**Re: Request for Modified Sediment Removal Limits
Interim Response Action Project
Diamond and Standard Chlorine Chemical Company Inc. Sites
Kearny, Hudson County, New Jersey**

SEDIMENT MANAGEMENT PLAN

FIGURE 1

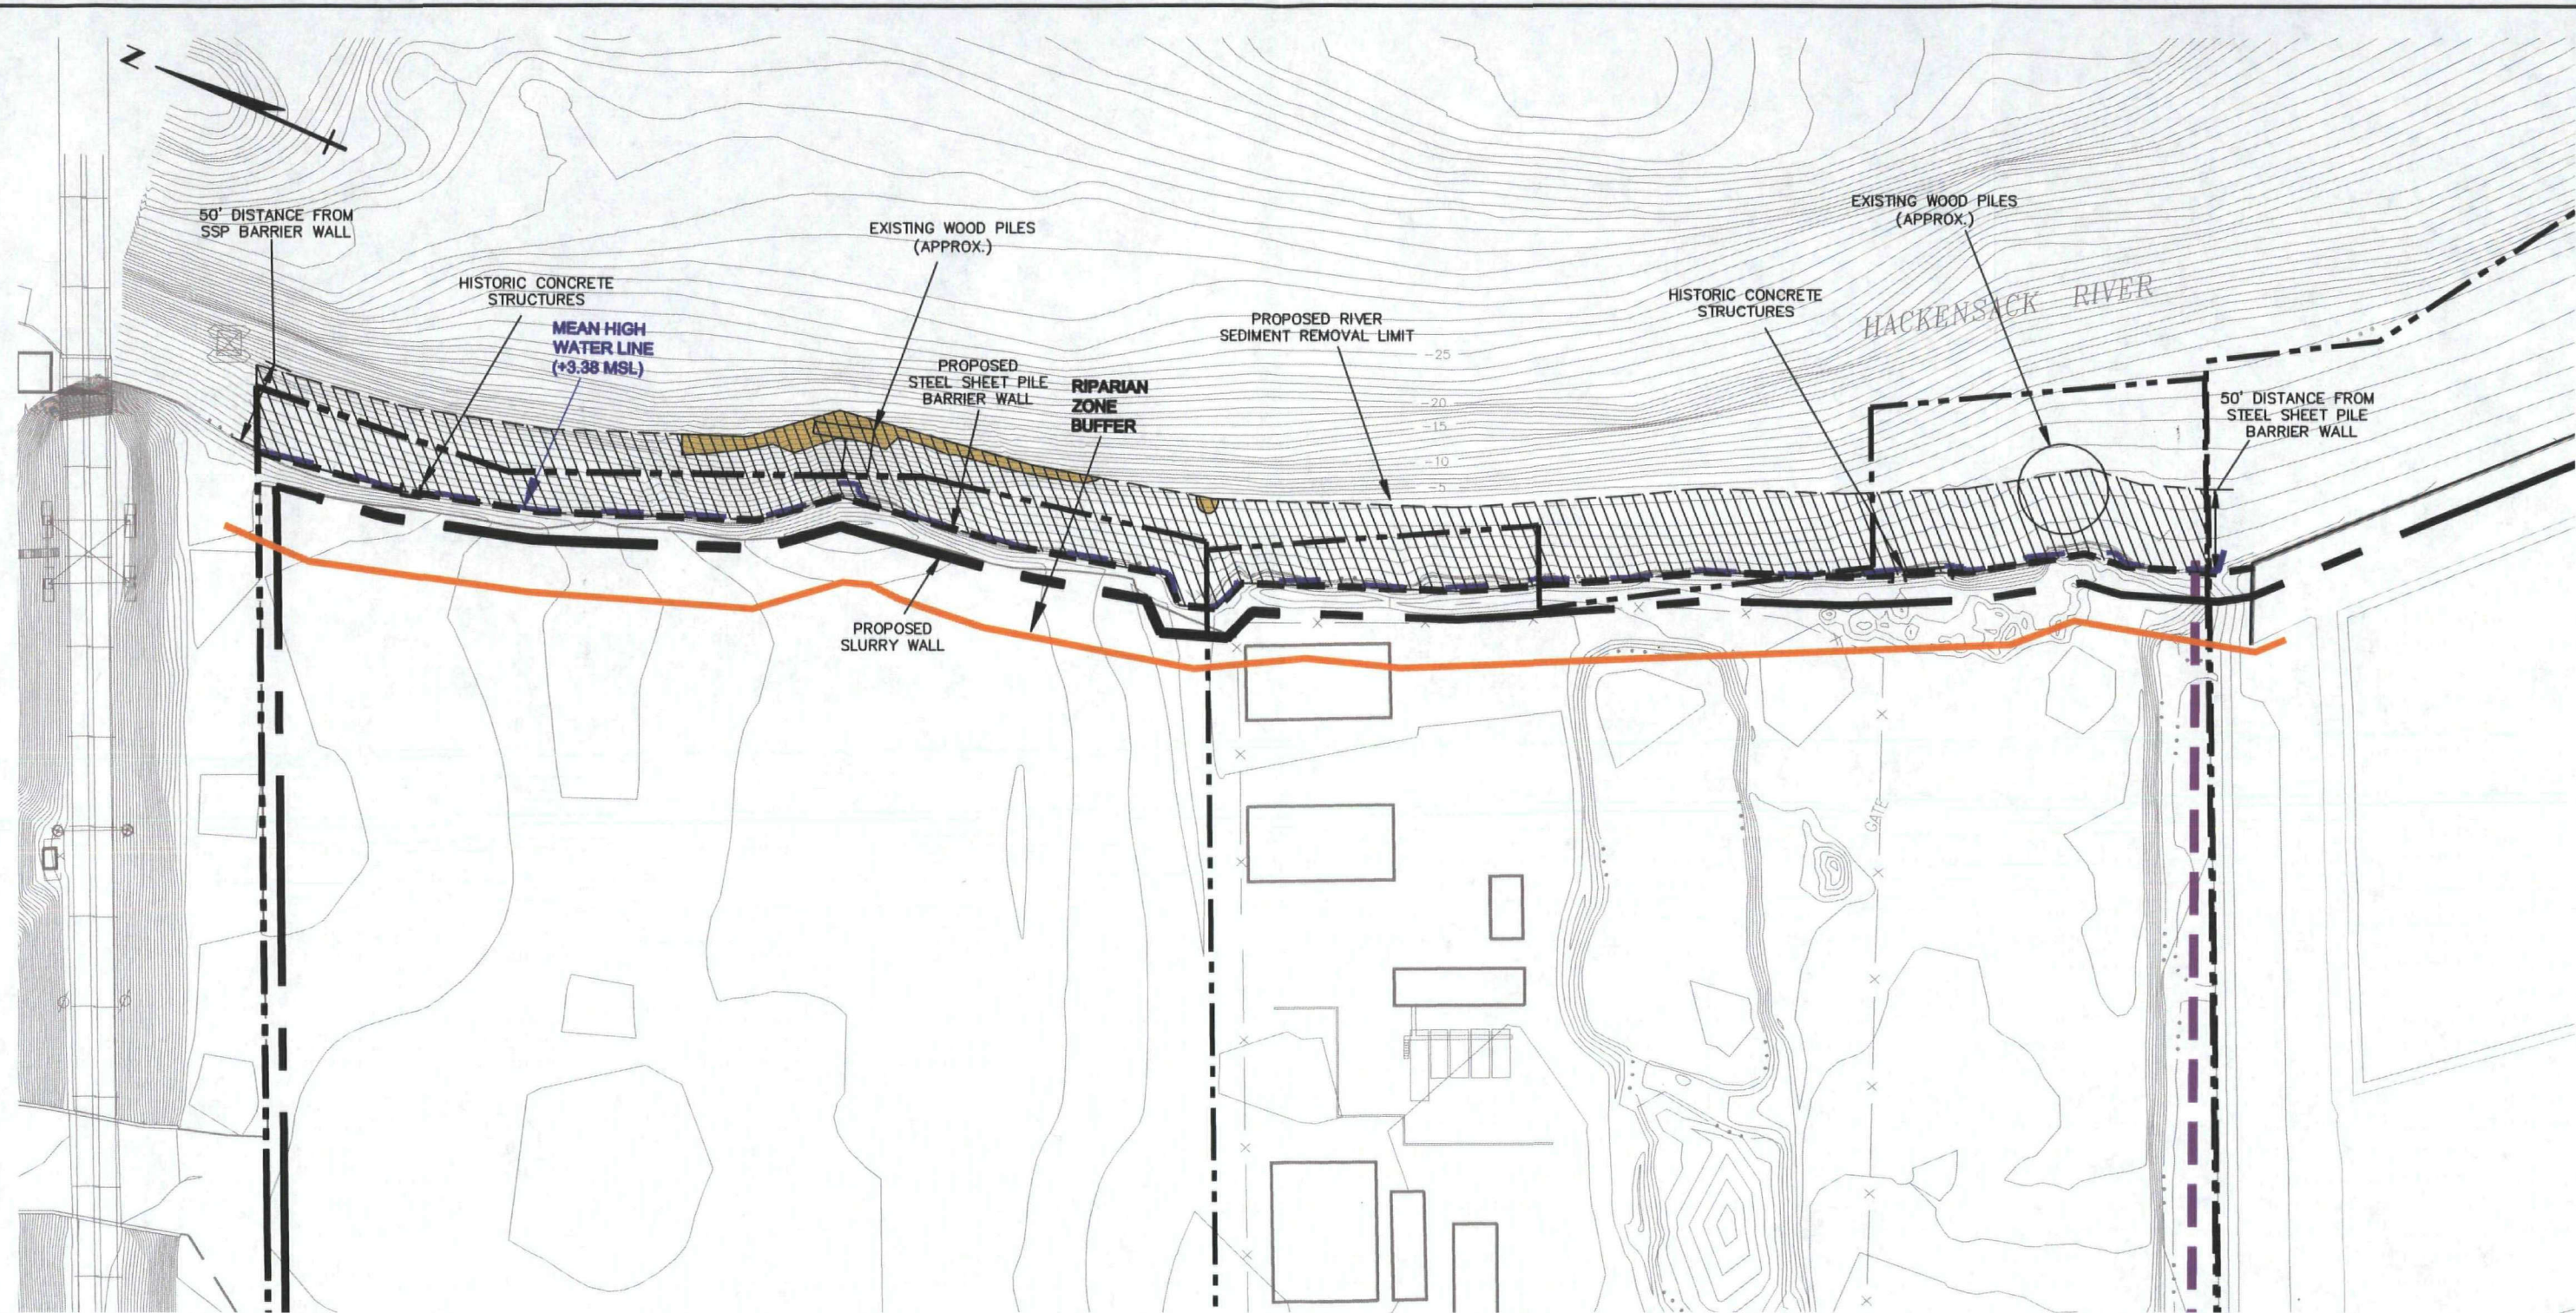
We believe that with the efforts made to date the intent of the sediment removal action has been honored, i.e., excavation of near-shore sediment to the practical limitation of commonly available construction equipment. As such, at this time the PRG is requesting NJDEP's

concurrence with a proposed revision of the IRAW-specified sediment removal limits, to account for the limited problematic areas that are beyond the practical and effective reach of the on-site excavation equipment.
